Re: Turkey Point Units 3 and 4
Docket Nos. 50-250 and 50-251
Response to Request for Additional Information Regarding
License Amendment Request for H*: Alternate Repair Criteria for
Steam Generator Tubesheet Expansion Region

Enclosure 1 – Page 1 of 2
Response to RAI Questions 19 and 20

**Westinghouse Electric Company LLC, LTR-SGMP-09-108 NP-Attachment, "Response to
NRC Request for Additional Information on H*; Model 44F and Model 51F Steam
Generators" August 27, 2009**

**Figure RAI4-2
Unit Cell Model and Loading Sequence**

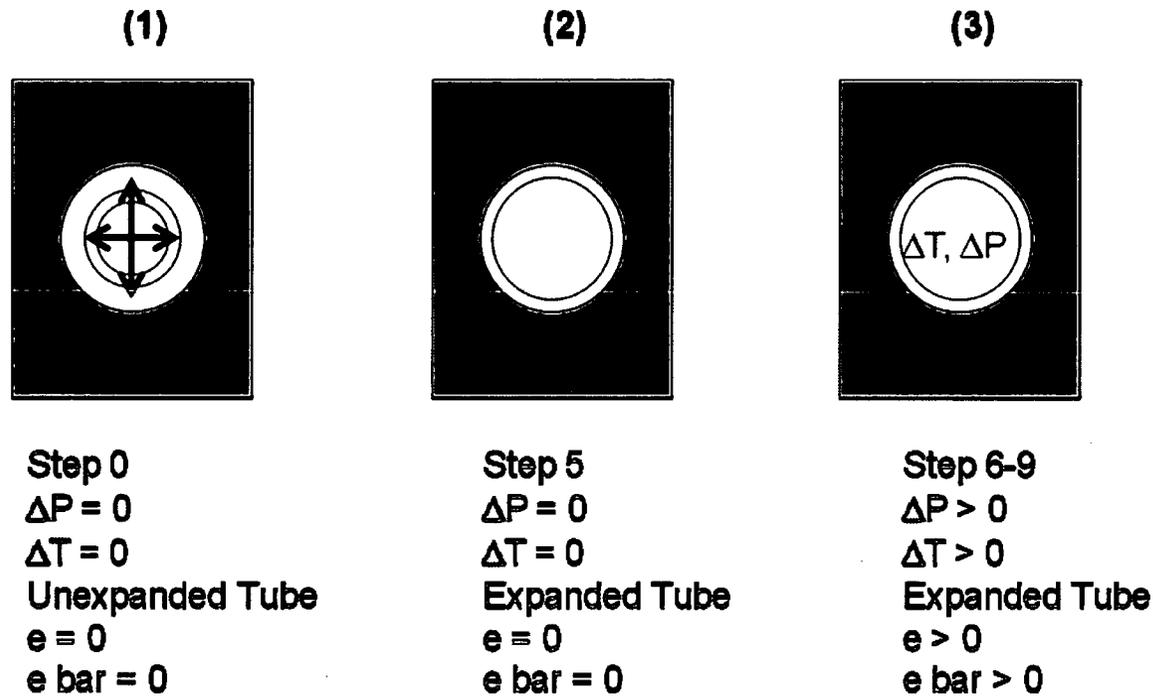
4. Provide the calculation basis for the upper and lower curves provided in Figure RAI 4-2
5. Resolve the apparent inconsistency between Item 4 on page 25 and the statement below Figure RAI4-1 regarding how the model in Figure RAI4-1 is loaded.

As discussed in Section 6.2.5 of the H* WCAP reports, the operating pressure loads, were applied to the initialized model in a sequential manner, and the resulting contact pressures were calculated when a range of displacements (termed "E-bar") were applied as boundary conditions to the model. Figure RA14-2 shows the updated sequential loading (includes application of thermal loads) of the model and relates it to the steps discussed in Section 6.2.5 and Tables 6-18 and 6-19 of the H* WCAPs. The "E-bar" values shown as the displacement inputs on Tables 6-18 and 6-19 in the H* WCAP reports are uni-directional displacements (in inches) that are NOT the same as eccentricity and also not the same as ΔD . (Eccentricity is defined as the difference between the maximum and minimum diameters of a bore divided by the nominal diameter of the bore. The units of eccentricity are inch/inch.) The displacement inputs applied to the unit cell model are assumed values that based on prior analyses that envelope the expected tubesheet displacement for all of the applicable operating conditions. It is important to note that the unit cell model as described in Section 6.2.5 of the H* WCAP reports utilizes boundary conditions chosen to minimize the tube-to-tubesheet contact pressures for the applied relative displacements.
